SUBJECT: Lansing Municipal Airport  
Lansing, Illinois  
Cook County  
Illinois Project Number: IGQ-4821  
SBG Project Number: 3-17-SBGP-156/TBD  
Contract No. LA044  
Item No. 06A, July 30, 2021  
Addendum A

## NOTICE TO PROSPECTIVE BIDDERS

Construction plan and special provision revisions issued as Addendum A.

REHABILITATE LIGHTING FOR  
RUNWAY 18-36 AND PARALLEL  
TAXIWAY

SHEET TITLE  
**AIRFIELD LIGHTING  
PLAN - 3**

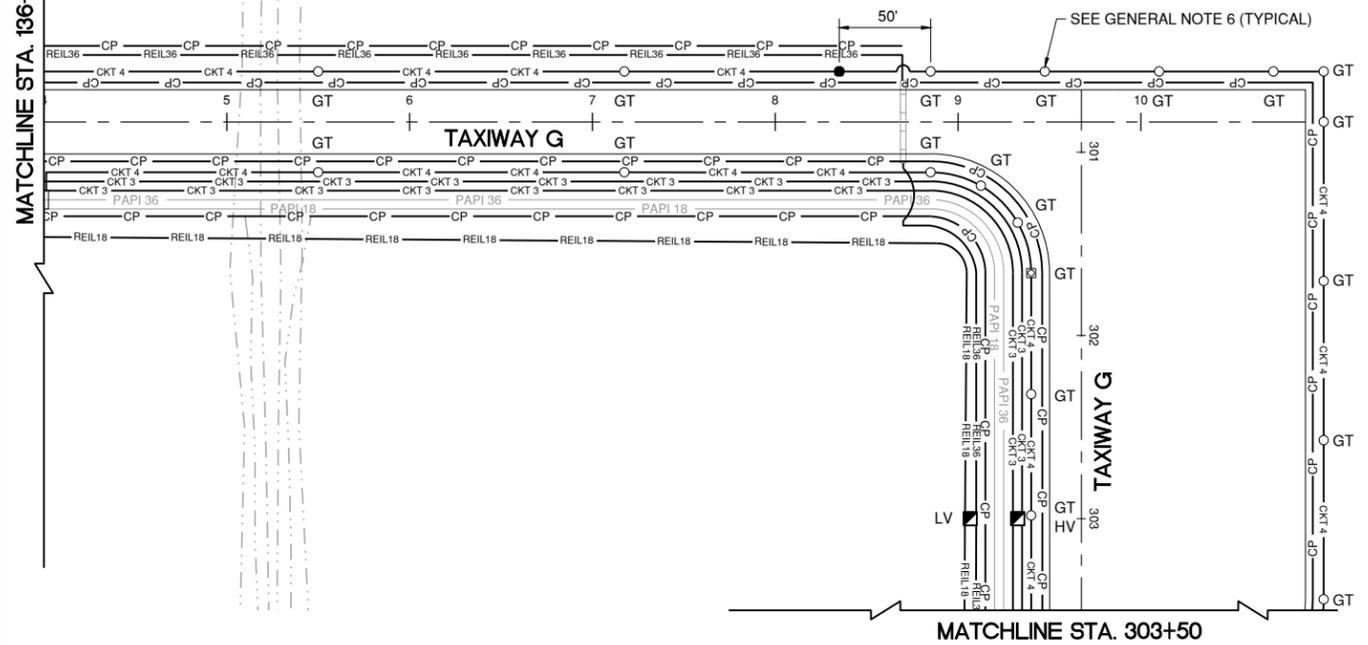
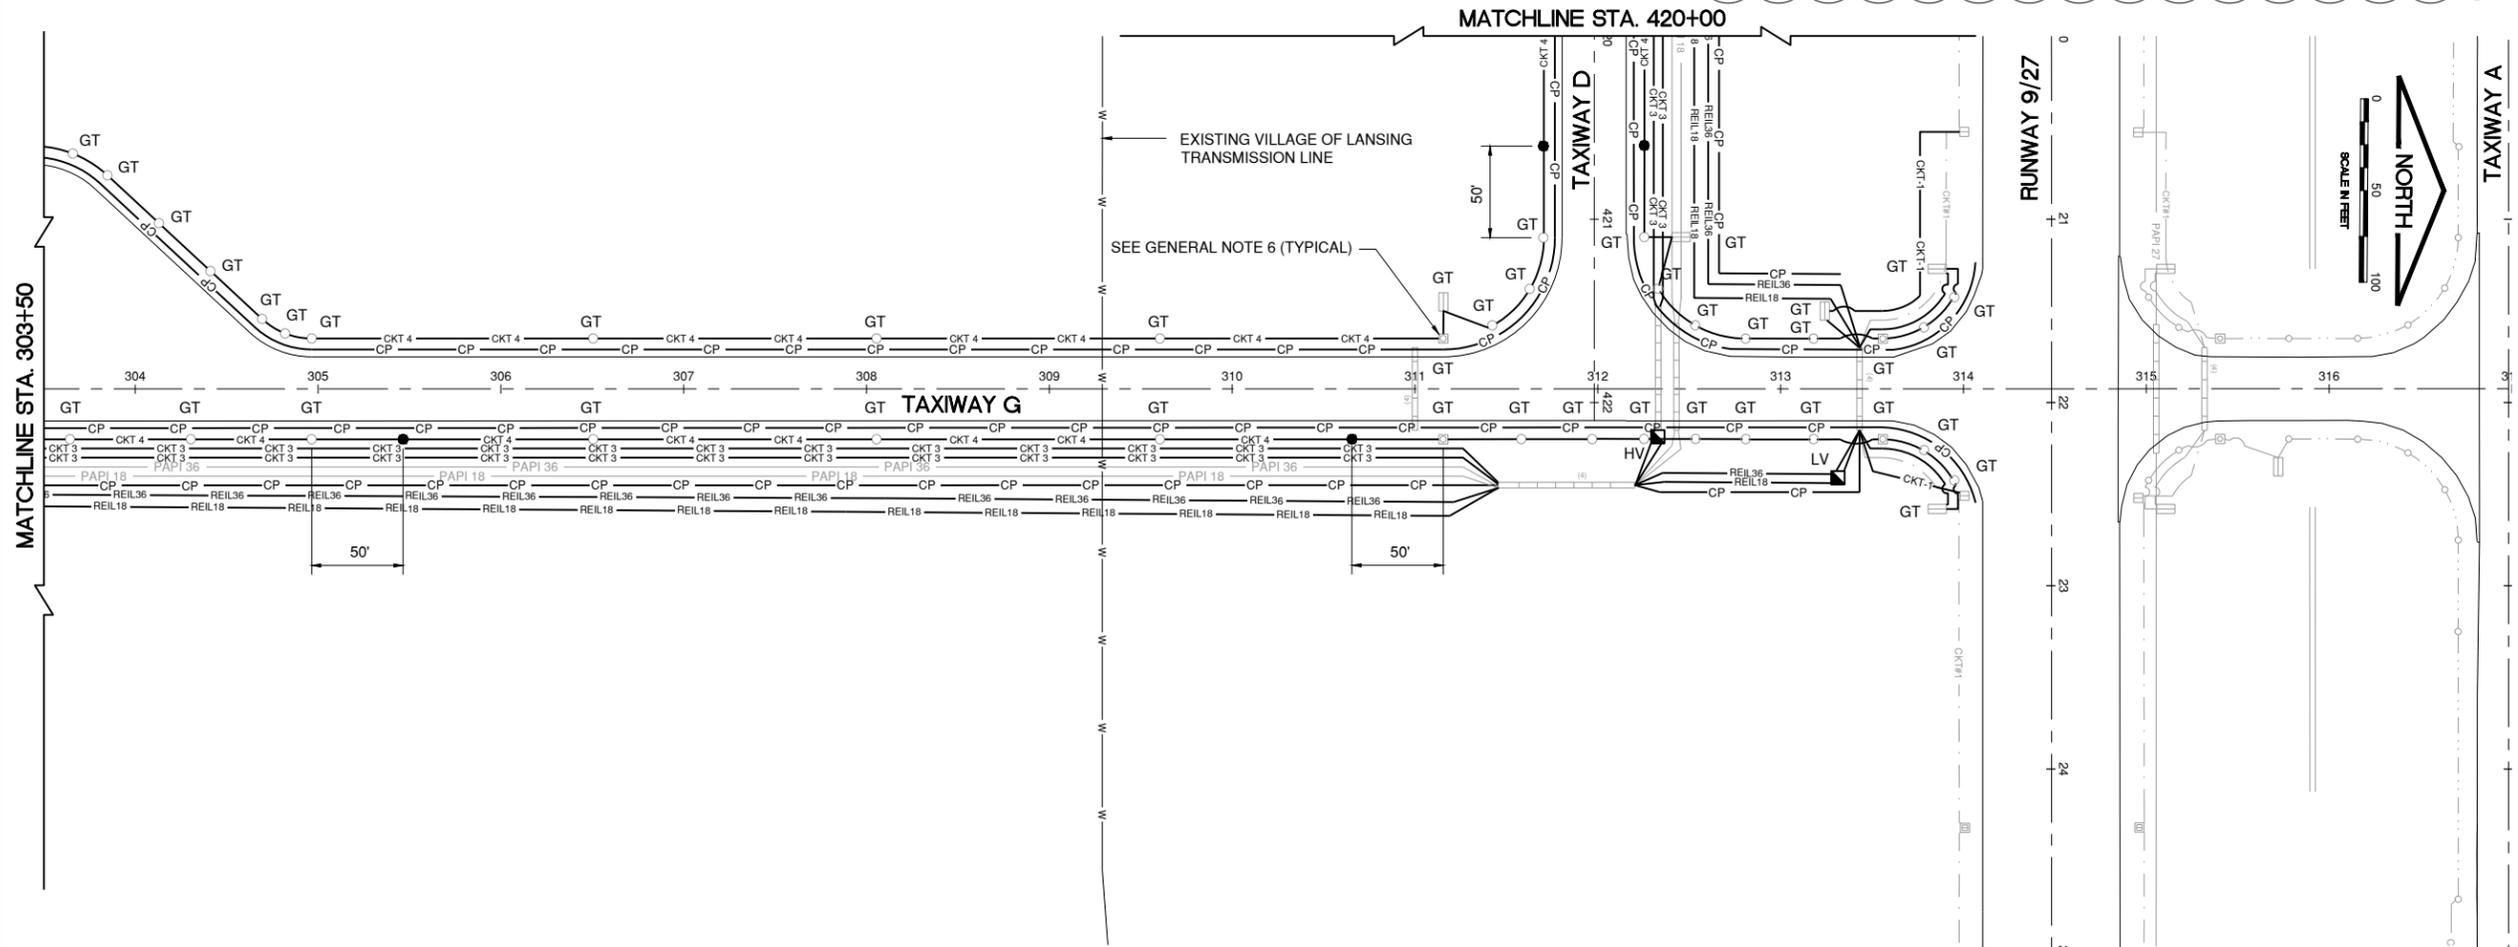
1. Replace Existing Plan Sheet 18 with Revised Plan Sheet 18
  - Added Note 15
2. Replace Existing Plan Sheet 21 with Revised Plan Sheet 21
  - Revised detail TURF AREA CABLE TRENCH DETAIL. High and low voltage cabling in common trench allowed. Twelve inch separation between high and low voltage cabling.
3. Replace Existing Plan Sheet 22 with Revised Plan Sheet 22
  - Revised detail COUNTERPOISE LCOATION DETAIL. Updated for ground rod spacing and low and high voltage cable spacing in common trench.

7/21/21 ADDED NOTE 15

TURF AREA CABLE TRENCH DETAIL  
NOT TO SCALE

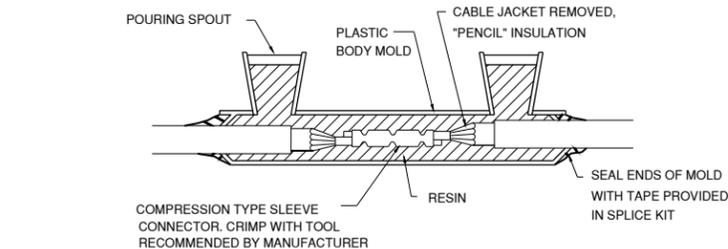
7/21/21 REVISED TURF AREA CABLE TRENCH DETAIL

1. TRENCHES WITH MORE THAN 2 CABLES SHALL BE INCREASED 4" IN WIDTH FOR EACH ADDITIONAL CABLE. IF SPECIFIED ON PLANS, TWO PARALLEL TRENCHES MAY BE CONSTRUCTED.
2. DEPTH OF TRENCHES SHALL BE AS SHOWN UNLESS OTHERWISE SPECIFIED ON THE PLANS.
3. SAND BACKFILL SHALL BE USED IF THE EXISTING SOIL DOES NOT MEET THE BACKFILL REQUIREMENTS.
4. ALL DISTURBED SURFACES SHALL BE RESTORED TO THEIR ORIGINAL CONDITION. COST IS INCIDENTAL.
5. COUNTERPOISE SHALL BE INSTALLED PER THE SPECIFICATIONS AND COUNTERPOISE LOCATION DETAIL.
6. LOW AND HIGH VOLTAGE CABLES MAY BE COLOCATED IN A COMMON TRENCH. SEPARATION BETWEEN HIGH AND LOW VOLTAGE CABLES SHALL BE INCREASED TO 12".
